## L4451A-02

# S E R V I C E N O T E

## L4451A 4-Channel Isolated D/A Converter with Waveform Memory

**Instrument cannot operate in 400 Hz**

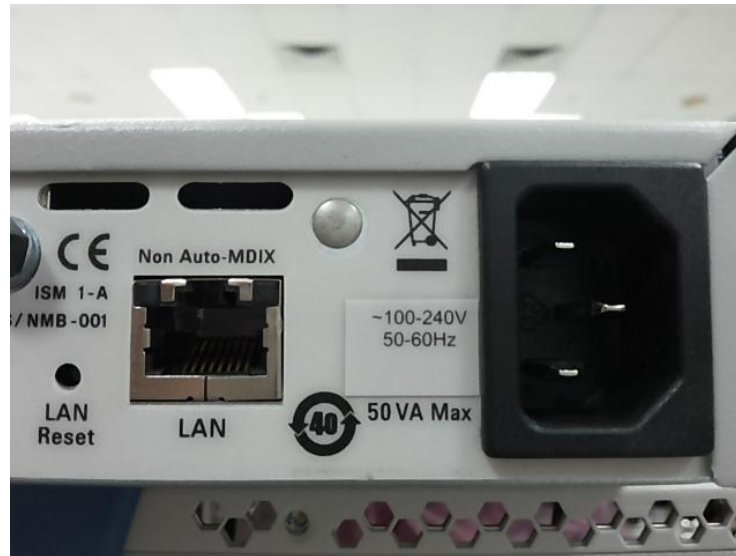
It has been found that the instruments with affected serial numbers listed above have incorrect information printed on the power rating label. The instrument does NOT support 400 Hz operation at 100-127V.

Order a L4421-84303 L44xxA Power Rating Label and apply it over the existing power rating information on the instrument. After applying the L4421-84303 label, it should look similar to the picture below.
